NOTICE OF MEETING
PLANNING AND ZONING COMMISSION
6:00 P.M. – August 11, 2022

PLANNING AND ZONING COMMISSION ITEM:
PC-22-11
FINAL PLAT
BULVERDE RV PARK

PLANNING AND ZONING COMMISSION ITEM:

PLANNING AND ZONING COMMISSION ITEM:
PC-22-23

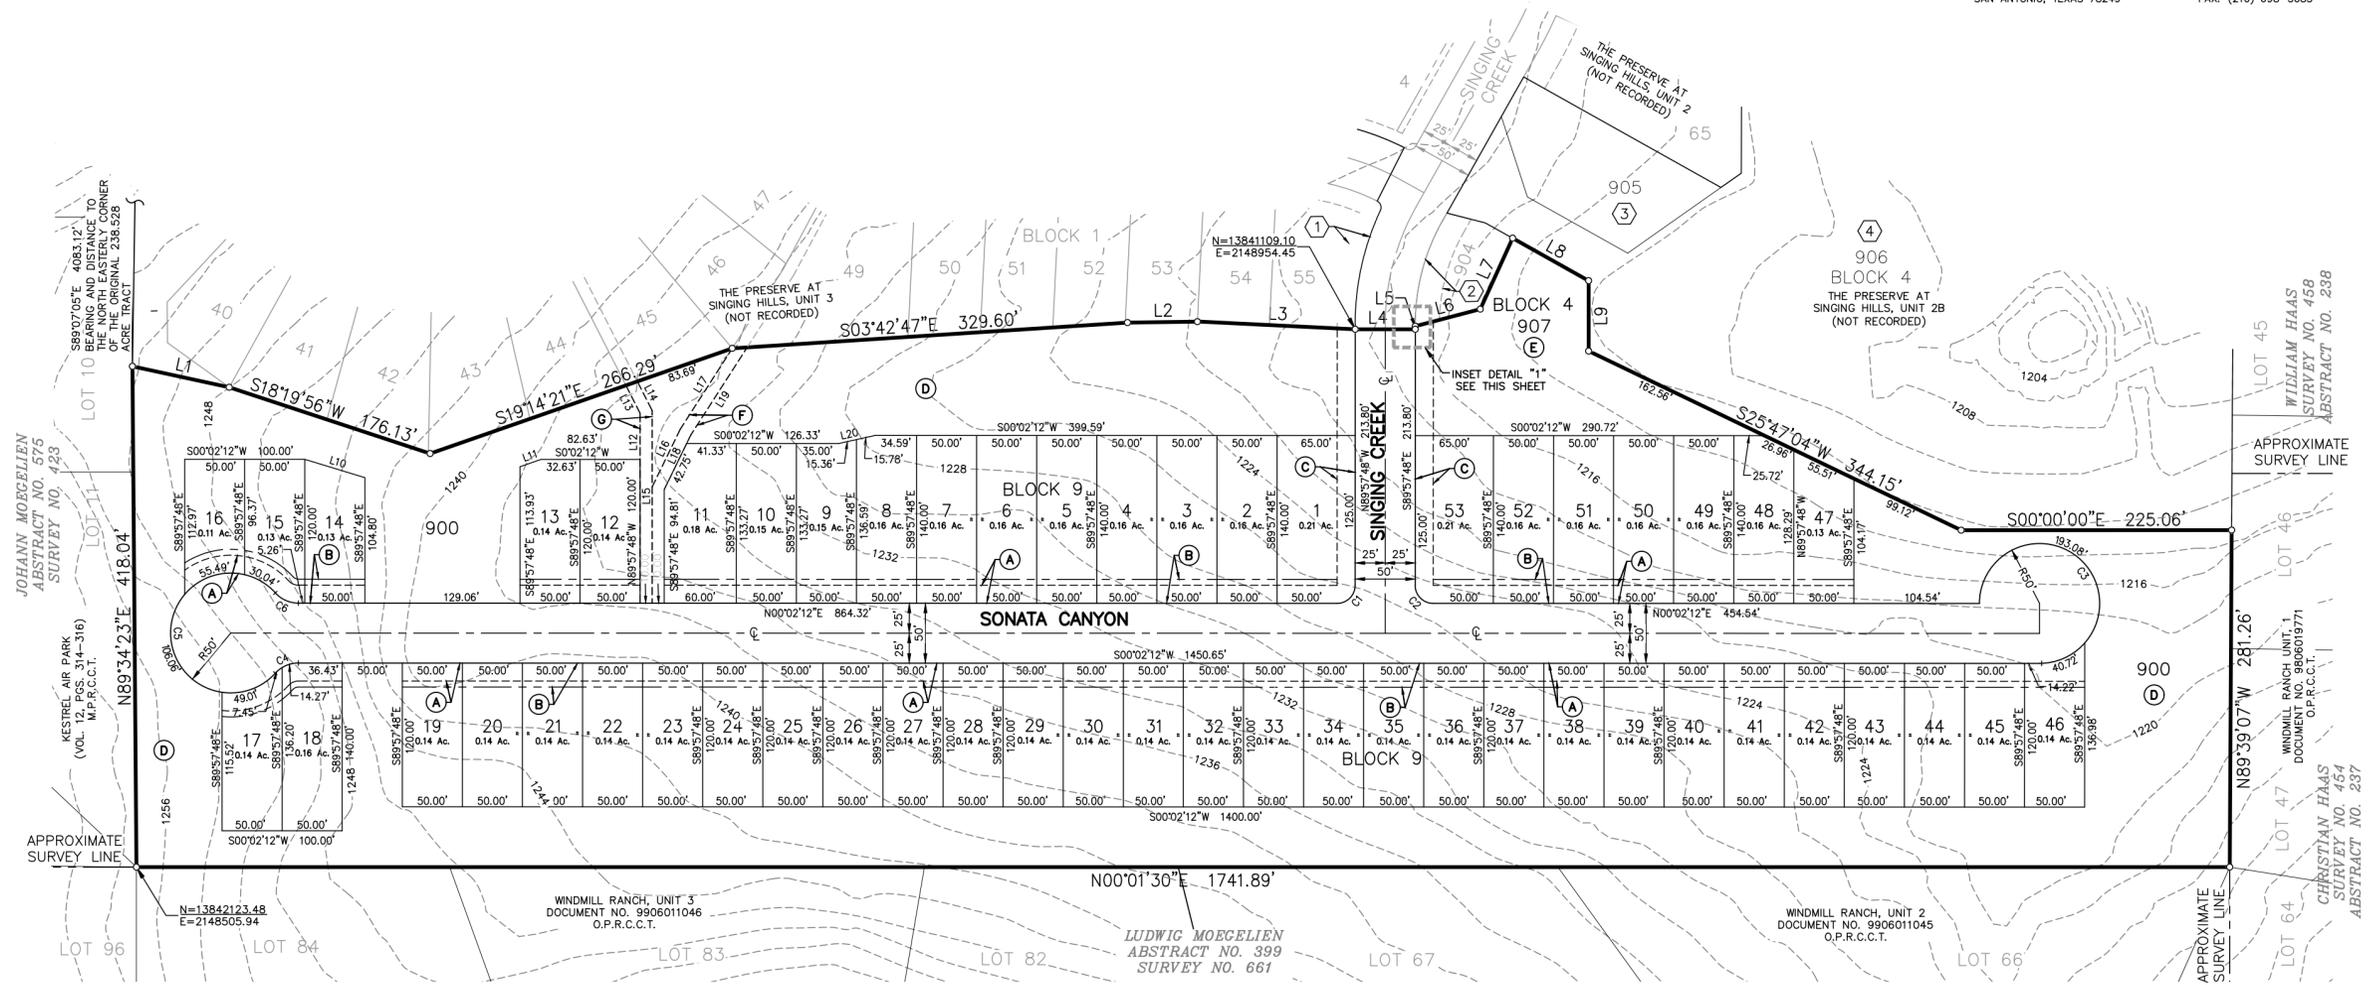
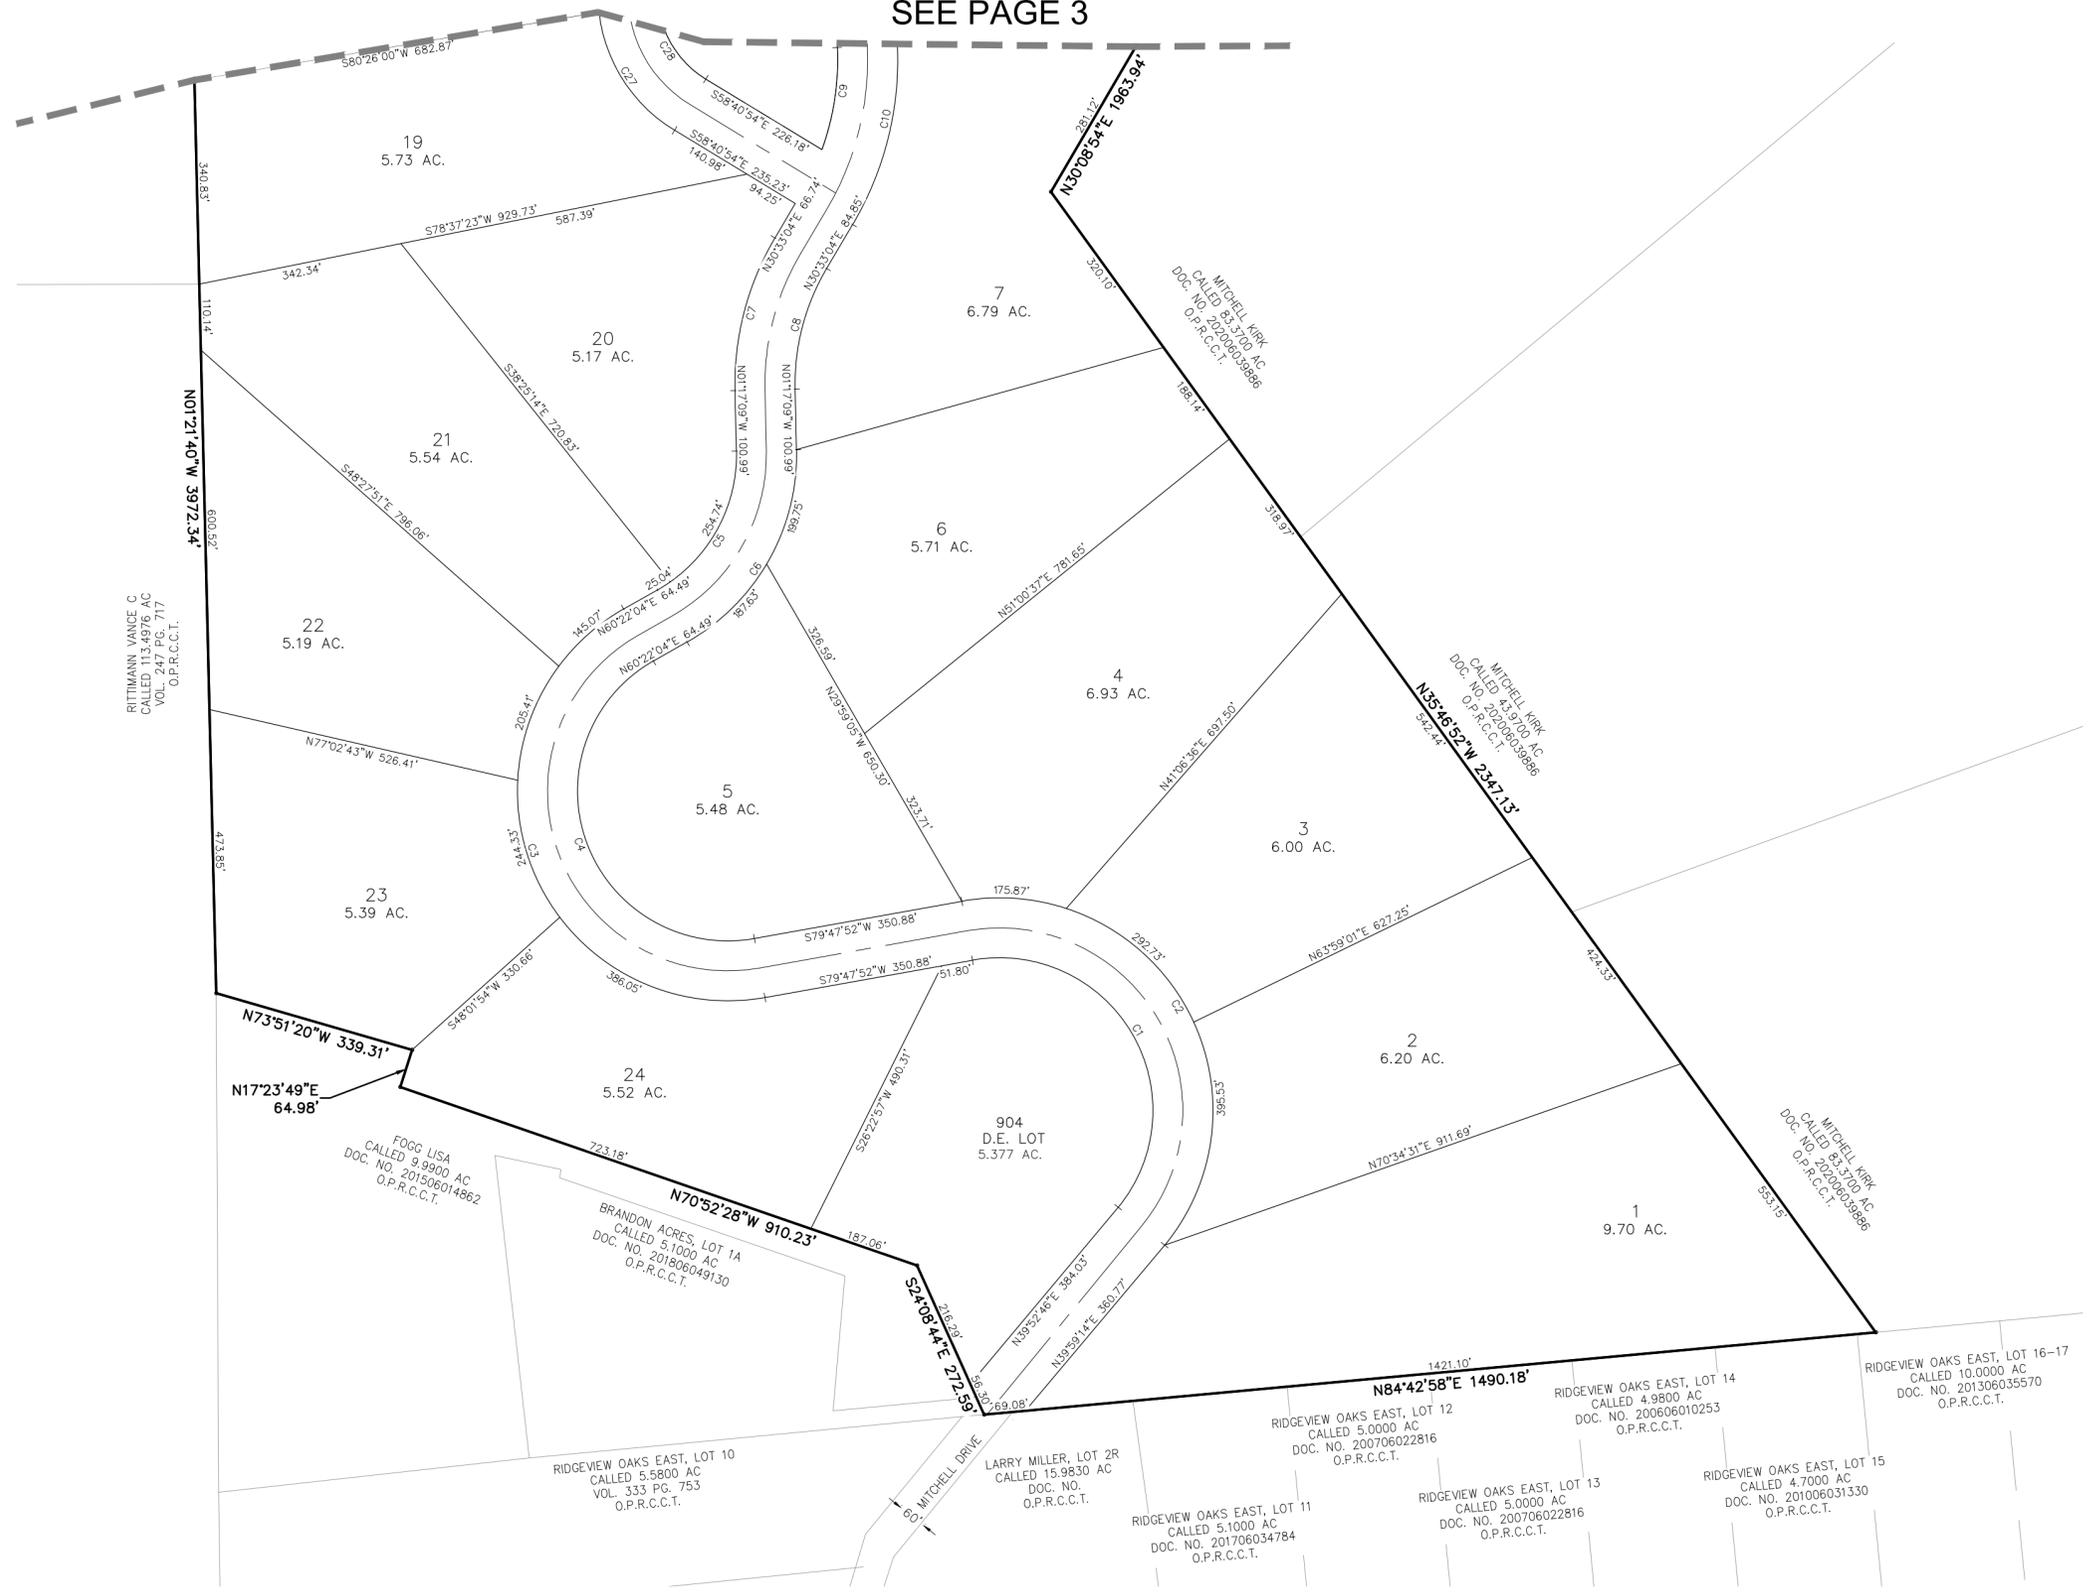
- 19. Add slope easements as required according to the updated slope map (see comment 41 below).
- 20. Show required riparian buffers as dedicated open space (see comment 33 below).
- 21. Update plat note #13 to refer to the County engineer, instead of the City engineer.
- 22. Update plat note #23 to reflect the appropriate impervious cover limitations used in the design for improvements within this subdivision.
- 23. Add note on Sheet 1 that notes on plat apply to all pages of the plat document.
- 24. Remove County Judge Signature Block and replace it with the Bulverde Planning & Zoning and Directors signature blocks as shown below with the plat name included and underlined:

- 25. Minimum lot frontage is 209-ft [Sec. 2.03(c)(iv)(1)].
- 26. Indicate and dedicate the required parkland for this subdivision [Sec. 2.03(e)].
- 27. Minimum centerline radius for a rural local street is 200-ft. Curve at the far north end of the subdivision (centerline between C19 & C20) appears to only be 132-ft [Sec. 2.04(e)(i)].
- 28. Roadway centerline should avoid "S" curves where possible by providing tangent pieces meeting code requirements. Reference Sec. 2.04(e)(iv) and adjust centerline alignment.
- 29. Intersection right-of-way radii shall meet requirements of Sec. 2.04(e)(vii).
- 30. Right-of-way should be dedicated at the end of Eagles View Drive to maintain the ability for public access to the adjacent Armstrong Living Trust tract on the north end of the subdivision.

31. Plat boundary differs from Comal County Appraisal District website information at the connection point to Mitchell Drive. Please ensure accurate boundary information is presented on the plat and full access to Mitchell Drive is available for roadway extension.

32. Per the Environmental assessment, two water wells are present on-site and should be identified on the plat/utility plan.
